UNITED STATES PATENT AND TRADEMARK OFFICE

APPLICATION NO.	FILING DATE	FIRST NAMED INVENTOR	ATTORNEY DOCKET NO.	CONFIRMATION NO.
10/780,320	02/17/2004	Jack E. Caveney	LCB432	1108
32915	7590	09/06/2007		
PANDUIT CORP. LEGAL DEPARTMENT - TP12 17301 SOUTH RIDGELAND AVENUE TINLEY PARK, IL 60477			EXAMINER GABLER, PHILIP FRANCIS	
			ART UNIT 3637	PAPER NUMBER
			MAIL DATE 09/06/2007	DELIVERY MODE PAPER

Office Action Summary	Application No. 10/780,320	Applicant(s) CAVENEY ET AL.	
	Examiner Philip Gabler	Art Unit 3637

Thiede et al. '498 Figures 2-4

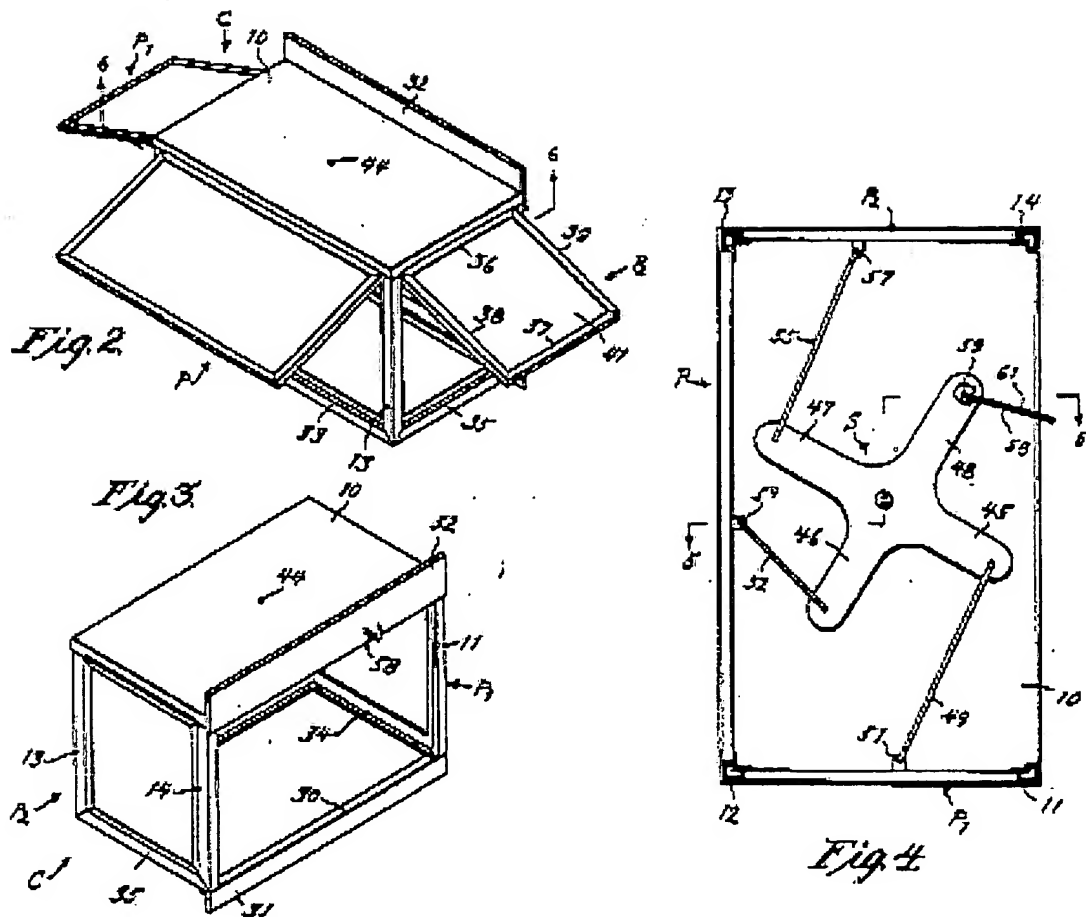
2. Claims 1 and 3 are rejected under 35 U.S.C. 102(b) as being anticipated by Thiede et al. (US Patent Number 3006498). Thiede (Figures 2-4) discloses a wall mountable cabinet comprising: a rear section (10-14, 31-35, etc.) having a top side (10), a bottom side (members 30, 33, 34, etc.), and a first side (formed by 11, 12, etc.) between the top side and the bottom side, the rear section including a cutout (space defined by members 12, 13, 33, etc.) extending from the first side along a portion of the top side, wherein the cutout is adapted to be capable of receiving a plurality of cables; and a front section (P) hingedly connected to the rear section at a pivot point (front edge of 10) adjacent the cutout, wherein the cutout is capable of allowing the plurality of cables to rotate about the pivot point when the cabinet is moved from a closed position to an open position (the opening and closing of front section, P, for instance).

3. Regarding claim 3, Thiede further discloses two side access panels (P1 and P2) hingedly connected to the front section (through mechanism S and links 49, 52, and 55).

Exhibit 1: Hansson '362 Figures 1, 2, and 4

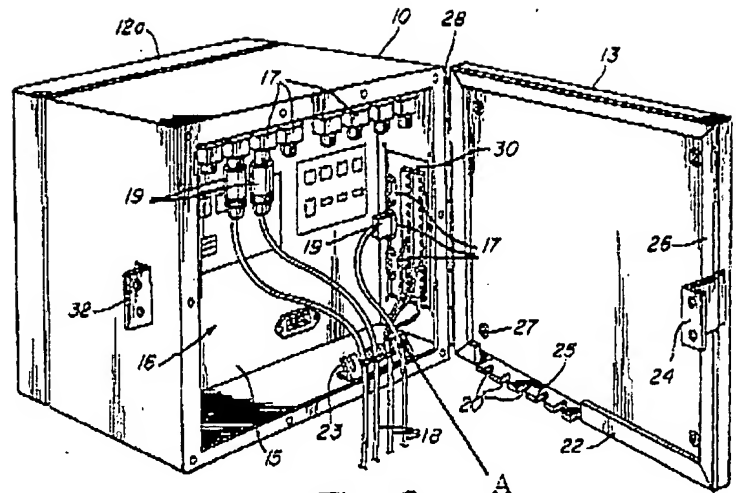
4. Claims 1, 4, 6, 7, 9, 11, 14, 17, 19, and 23 are rejected under 35 U.S.C. 102(b) as being anticipated by Hansson (US Patent Number 5568362). [Note that for the 35 USC 102(b) rejections in view of Hansson, Hansson's device is viewed in an inverted position as shown in Exhibit 2.] Hansson (Figures 1, 2, and 4) discloses a wall mountable cabinet comprising: a rear section (13) having a top side (at member 22), a bottom side (opposite member 22), and a first side (hinge side of 13) between the top side and the bottom side, the rear section including a cutout (at 20) extending from the

6. Regarding claim 6, Hansson further discloses a slack cable manager (viewed as A in Exhibit 1) secured to a rail (23) mounted therein.

9. Regarding claim 11, Hansson discloses a wall mountable cabinet comprising: a rear section (13) having a top side (at member 22), a bottom side (opposite member 22), and a first side (hinge side of 13) between the top side and the bottom side, the rear section including a cutout (at 20) extending from the first side along a portion of the top side, wherein the cutout is adapted to receive a plurality of cables; and a front section (10) hingedly connected to the rear section (through hinge 28), the front section having a cable management ring (A, which points to a cable tie secured to tie bracket

23, the cable tie being viewed as a cable management ring) secured thereon, wherein the cable management ring is adapted to be capable of enclosing the plurality of cables, wherein when the cabinet is in a closed position, the cable management ring is vertically aligned with the cutout (as is clear in Figure 2, where a vertical cable, 18, passes through the cable management ring and is aligned to enter the cutout upon closure of the cabinet).

Ehrenfels '129 Figures 1, 2, and 5

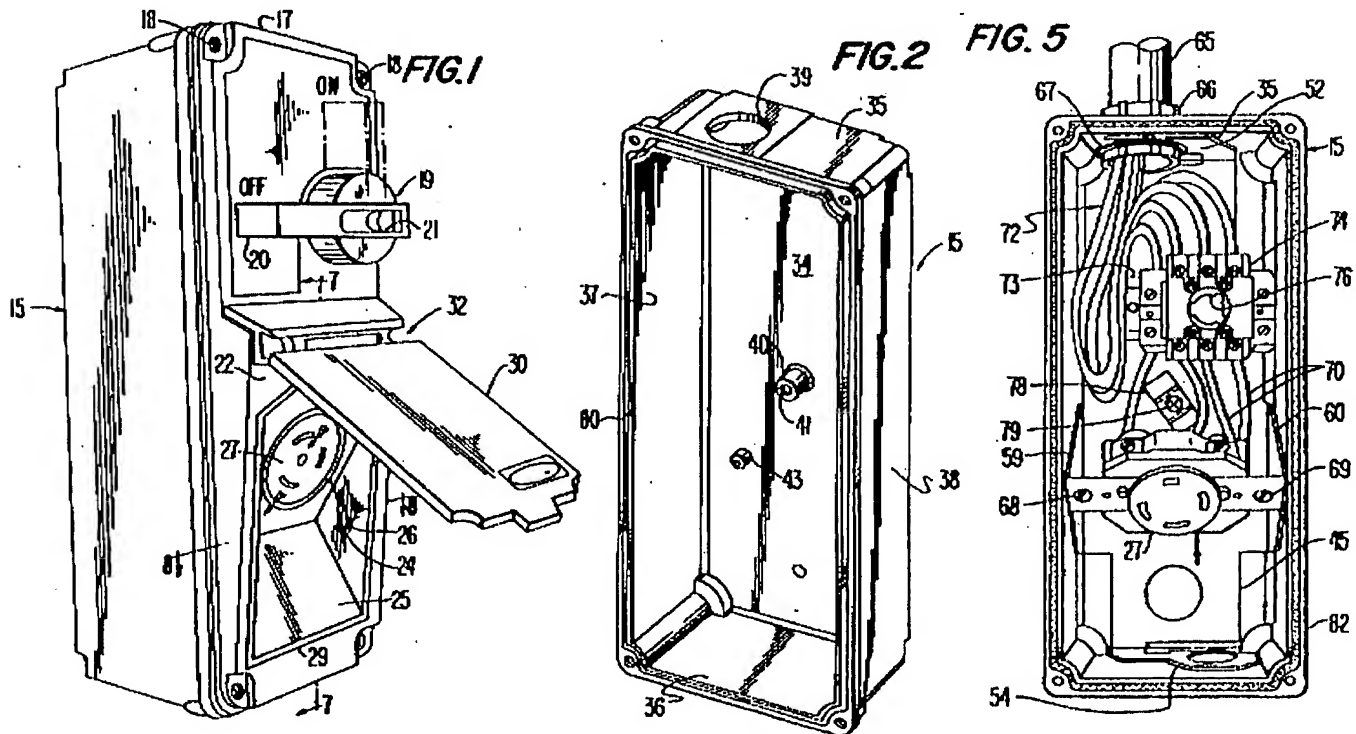
25. Claims 2 and 12 are rejected under 35 U.S.C. 103(a) as being unpatentable over Hansson in view of Ehrenfels (US Patent Number 5239129). Hansson discloses a wall mountable cabinet as recited in claims 1 and 11 as described above but does not disclose a duct positioned adjacent the cutout. Ehrenfels discloses a wall mountable cabinet with a duct (65) adjacent to a cutout (39). Accordingly, it would have been obvious to one of ordinary skill in the art at the time the invention was made to modify

Hansson's cabinet to include a duct positioned adjacent to the cutout as taught by Ehrenfels because this arrangement would protect cables routed through the cutout.

Nelson et al. '966 Figure 17

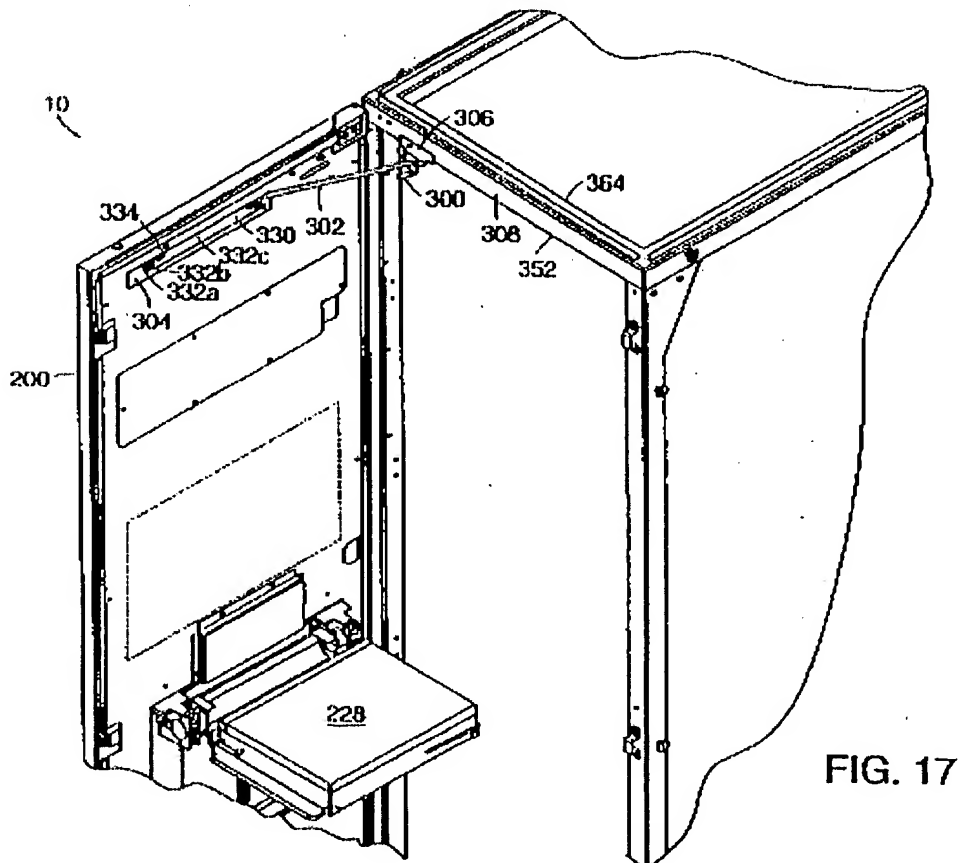
26. Claims 5 and 15 are rejected under 35 U.S.C. 103(a) as being unpatentable over Hansson in view of Nelson et al. (US Patent Number 6061966). Hansson discloses a wall mountable cabinet as recited in claims 1 and 11 as described above but does not disclose a rod which maintains the front section in an open position. Nelson (Figure 17) discloses a cabinet comprising a rod (302) which maintains the front section (200) in an open position about 90 degrees from the rear section (308). Accordingly, it would have been obvious to one of ordinary skill in the art at the time the invention was made to

modify Hansson's cabinet to include a rod to maintain the front section in an open position as taught by Nelson because this arrangement would facilitate access to Hansson's cabinet by providing a prop for the front section.

English et al. '233 Figure 1

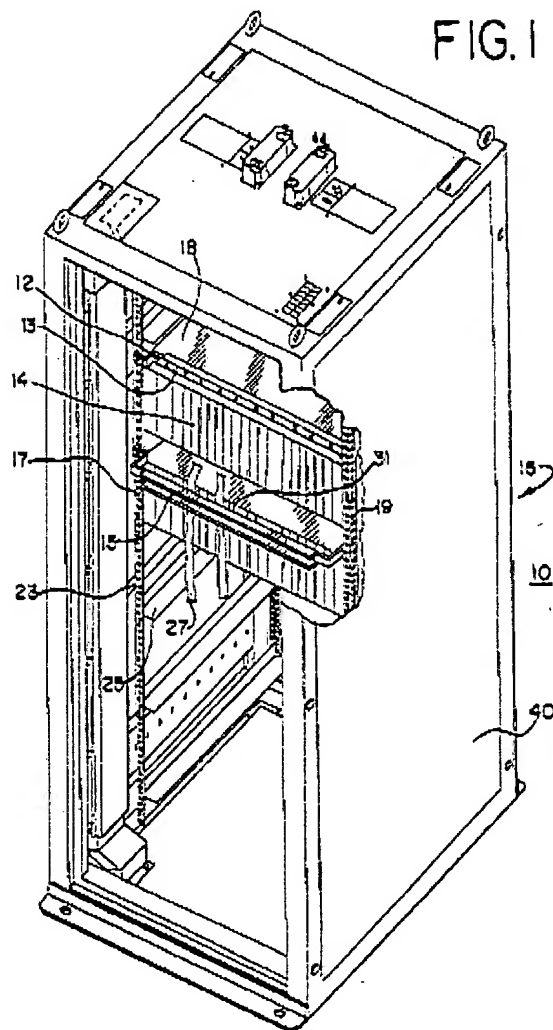
27. Claims 8, 10, 16, 18, and 22 are rejected under 35 U.S.C. 103(a) as being unpatentable over Hansson in view of English et al. (US Patent Number 6067233). Hansson discloses a wall mountable cabinet as recited in claims 1 and 11 as described above but does not disclose a horizontal cable manager secured to a rail. English (Figure 1) discloses a bar (12) mounted to a rail (17) intended for both cable

management use and mounting of electronic modules (see column 3 lines 59-62) and that is capable of supporting a slack cable manager, horizontal cable manager, patch panel or active equipment as is known in the art. Accordingly, it would have been obvious to one of ordinary skill in the art to modify Hansson's cabinet to include a cable manager or electronic component mount secured to a rail system as taught by English because this arrangement would provide more versatility to Hansson's cabinet while maintaining organization.

28. Regarding claims 10 and 22, Hansson discloses a wall mountable cabinet as recited in claims 4 and 14 as described above but does not disclose an adjustable rail. English discloses a rail (12) that can be adjusted (via holes 23) to various positions within a cabinet (10). Accordingly, it would have been obvious to one of ordinary skill in the art at the time the invention was made to modify Hansson's cabinet to include an adjustable rail as taught by English because this would allow greater flexibility as to what could be mounted in his cabinet.

Erickson '319 Figure 1

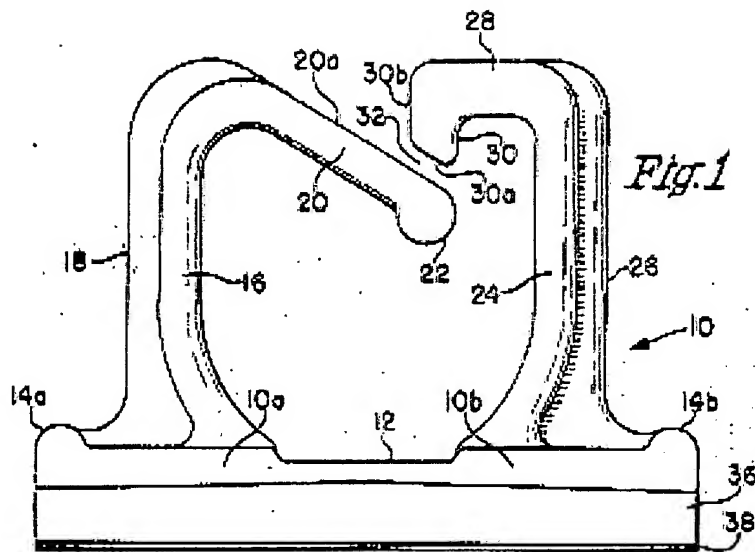
30. Claims 21 and 24 are rejected under 35 U.S.C. 103(a) as being unpatentable over Hansson in view of Erickson (US Patent Number 3659319). Hanson discloses a wall mountable cabinet as recited in claim 11 as described above but does not disclose a cable management ring with substantially L-shaped arms. Erickson (Figure 1) discloses a wire management clip with first (16 and 20) and second (24 and 28) substantially L-shaped arms having distal portions (20 and 28) oriented substantially 90 degrees from substantially linear portions (16 and 24), wherein the arms are formed of a material and construction capable of providing rotation (i.e. plastic; see column 2 lines 17-18) about the axis of their linear portions. Accordingly, it would have been obvious to one of ordinary skill in the art at the time the invention was made to modify Hansson's cable management ring to include substantially L-shaped arms as taught by Erickson because this arrangement would make securing and removing cables from the ring more efficient.
